**DOMINION NUCLEAR NORTH ANNA, LLC**  
**NORTH ANNA EARLY SITE PERMIT APPLICATION**  
**RESPONSES TO DRAFT SAFETY EVALUATION REPORT OPEN ITEMS**

**Responses to Draft Safety Evaluation Report  
Open Items 2.5-1 and 2.5-2**

**DSER Open Item 2.5-1 (DSER pages 2-165 and 2-166)**

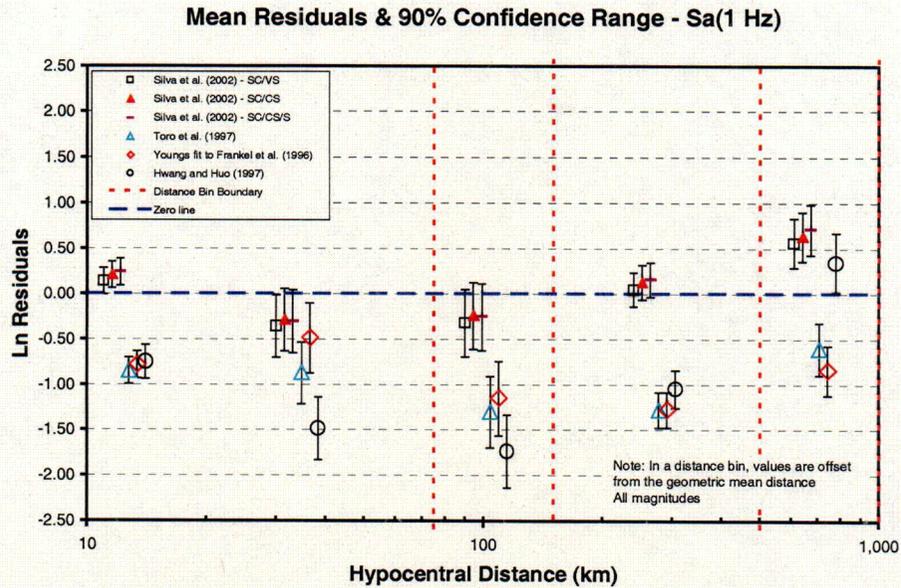
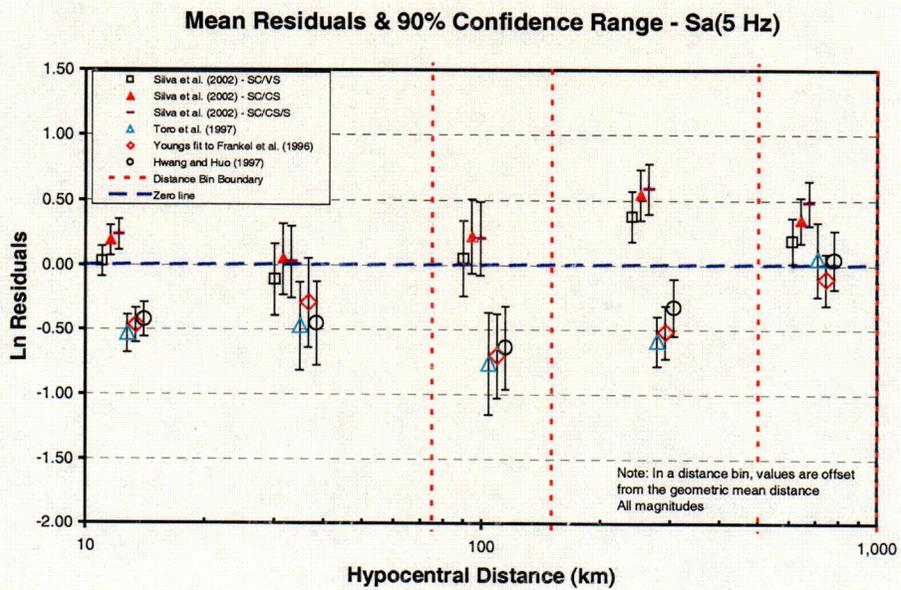
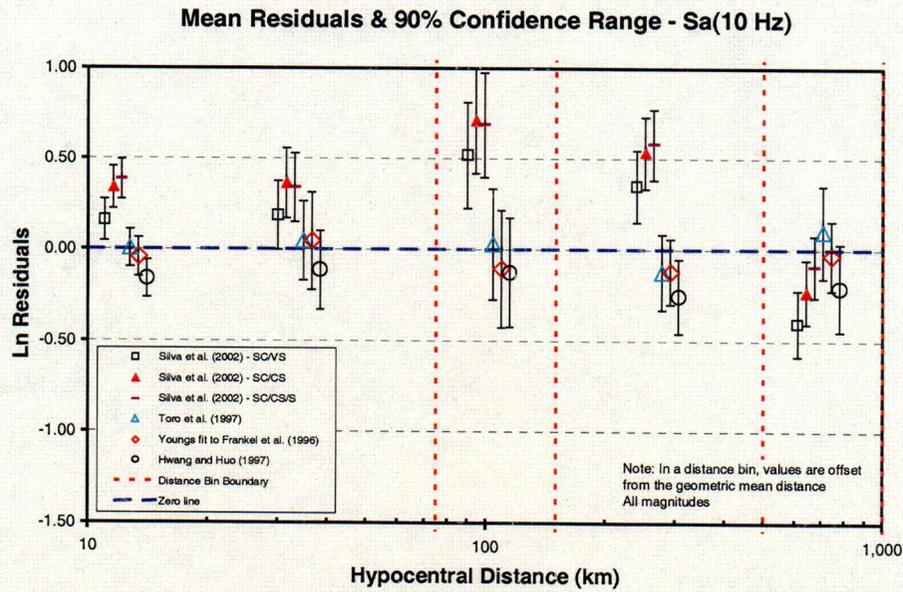
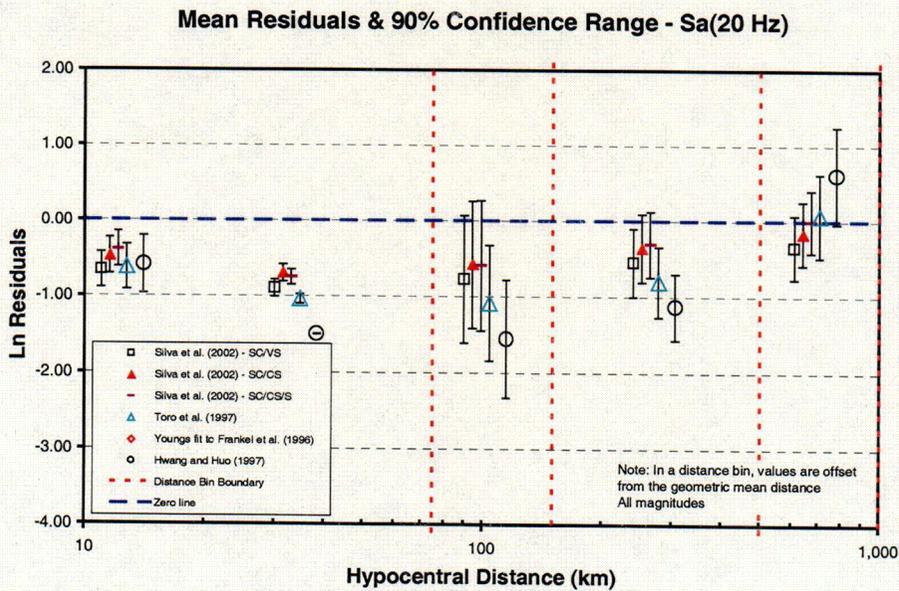
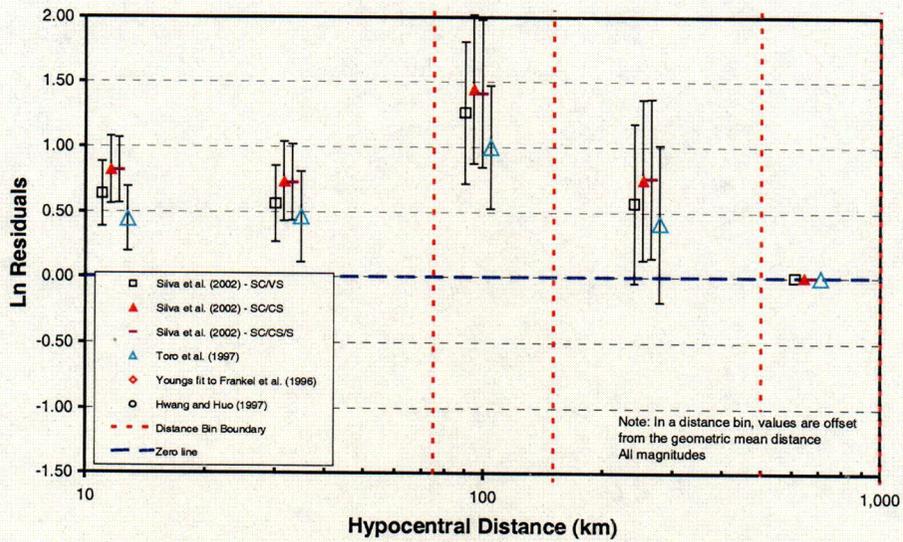
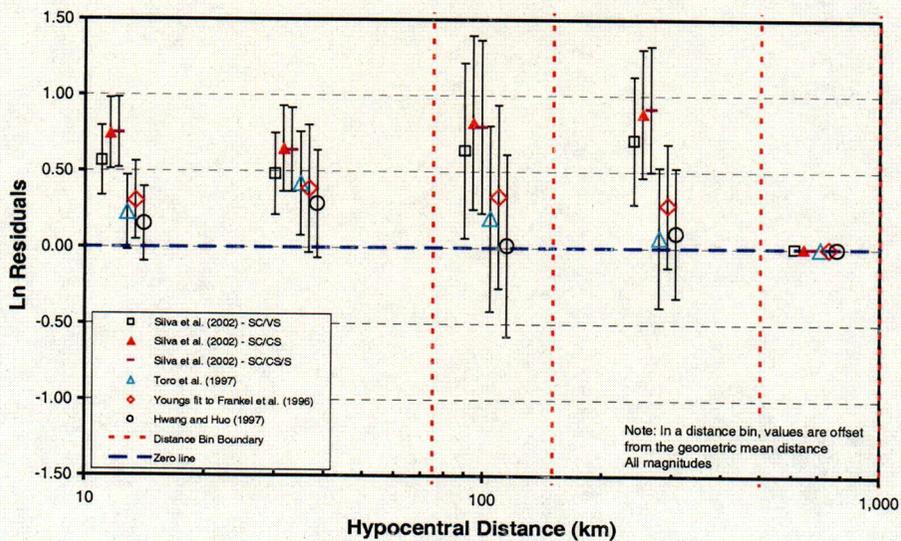
Provide residual plots (similar to Figure A-13 in the EPRI 2004 report) for each cluster 1 attenuation relationship for a range of frequencies (1 Hz to PGA) along with statistics for misfits (similar to Table A-4 in the EPRI 2004 report) for each frequency value. Show the calculation of the variance ( $\beta^2$ ) and final weight for each of the models.

Figures 1 through 6 provide plots of residuals [Mean ( $\delta$ ), Equation A-2] and the 90% confidence range. Corresponding to the tables, the residuals are plotted in five groups of differing distance bins. The 0 – 1000 km residuals are plotted at the left side of the plots, for plotting purposes around 12 km. Note that the residuals plots for 20 Hz, 25 Hz, and PGA are shown for illustration only, as they were not used in the intracluster weighting methodology, which focused on the frequencies of particular interest in Regulatory Guide 1.165 – that is, frequencies of 1 to 10 Hz.

Figure 1. Shear wave data and "best fit" line.

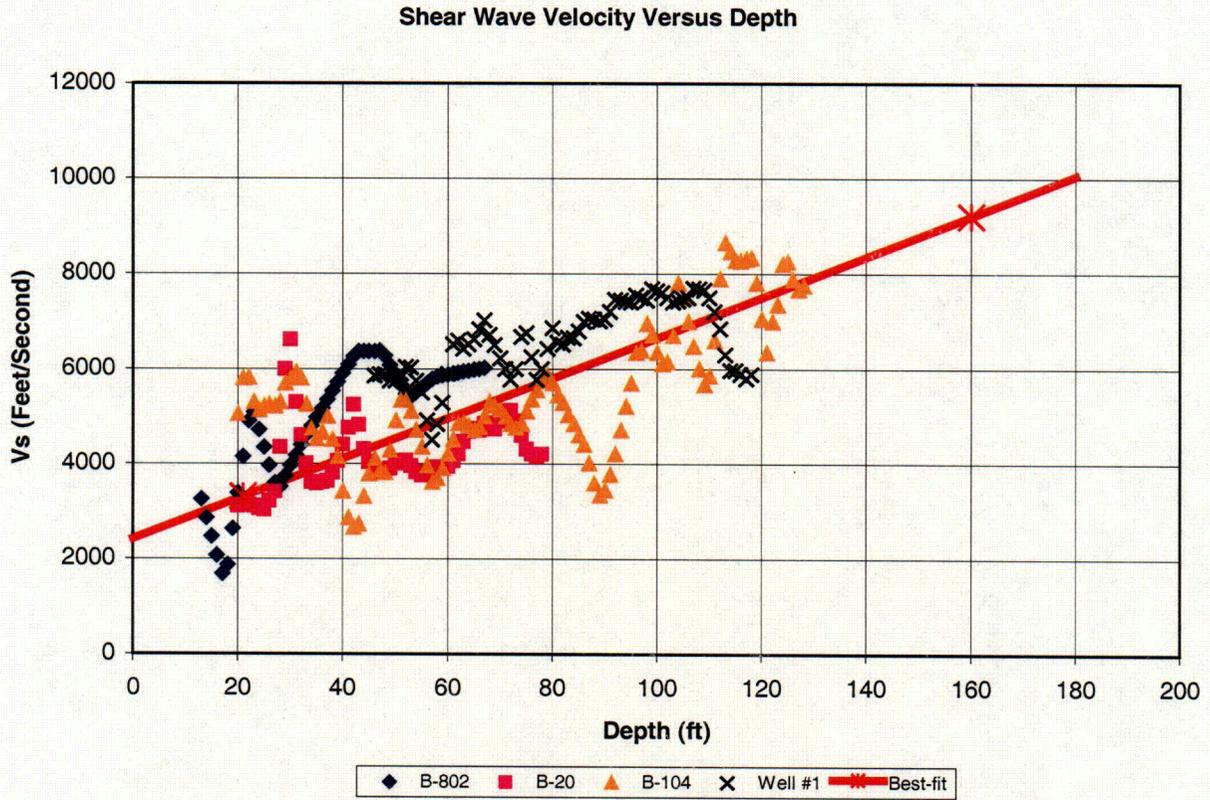
As explained in more detail below, the staff has determined that the applicant's SSE does not represent the free-field ground motion at the free ground surface.

Figure 2.5.2-5, which reproduces SSAR Figure 2.5-62, shows that the shear wave velocity values for the ESP site reach a value of about 2500 feet per second (ft/s) at a depth of 60 feet.

This shear wave velocity value is well below that of the hard rock conditions ( $V_s = 9200$  ft/sec) assumed by the EPRI 2003 study for CEUS ground motion models. In addition, the applicant did not make shear wave velocity measurements at a depth greater than 65 feet. Thus, the hard rock shear wave velocity value of 9200 ft/s may not be reached at the ESP site until a considerable depth below the ground surface. According to SSAR Figure 2.5-62, from the ground surface to a depth of 30 feet, the shear wave velocity at the ESP site varies from 600 ft/s to about 1300 ft/s. The applicant needs to incorporate these lower shear wave velocities, as well as other subsurface material properties and their uncertainties, into the determination of the ESP site SSE. In addition, the applicant should provide the site amplification or transfer function for the staff to review. The staff needs this information to determine that the applicant has provided an SSE that meets the requirements of Appendix S to 10 CFR Part 50 and 10 CFR 100.23, which define the SSE as "free-field ground motion response spectra at the free ground surface." This is **Open Item 2.5-2**.

The 1-ft interval shear wave velocity values in Table 1 for B-20, B-104, W-1, and B-802 are plotted against depth in Figure 1. As shown in Figure 1, starting at  $V_s = 3,300$  ft/sec at 21 ft depth, a visual "best-fit" line through the data reaches 9,200 ft/sec at around 160 ft depth.
